**STAFF REPORT**  
**(One-Step Final Plat)**

**CASE NUMBER:** SUB 2003-59 -- STARBUCK'S ADDITION

**LOCATION:** West side of West Street, South of Maple

SUB 2003-59: STARBUCK'S ADDITION

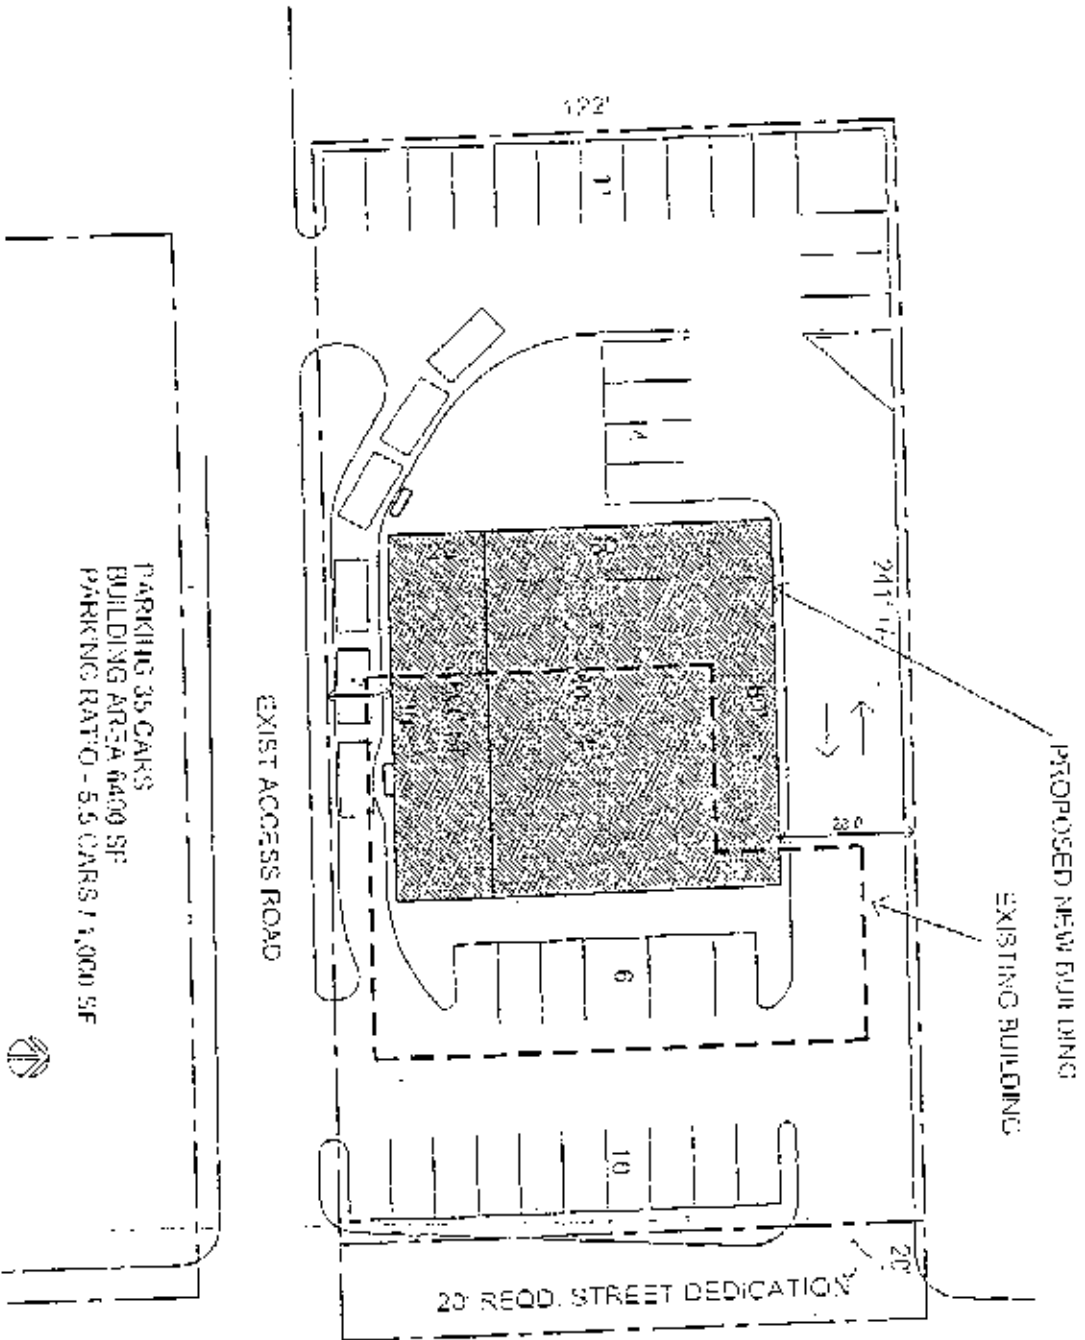
- C. City Engineering needs to comment on the status of the applicant's drainage plan.
- D. Traffic Engineering needs to comment on the access controls. The plat proposes one access opening along the north property line. Traffic Engineering has requested complete access control along West Street. A cross-lot access agreement is needed with the abutting property to the south.
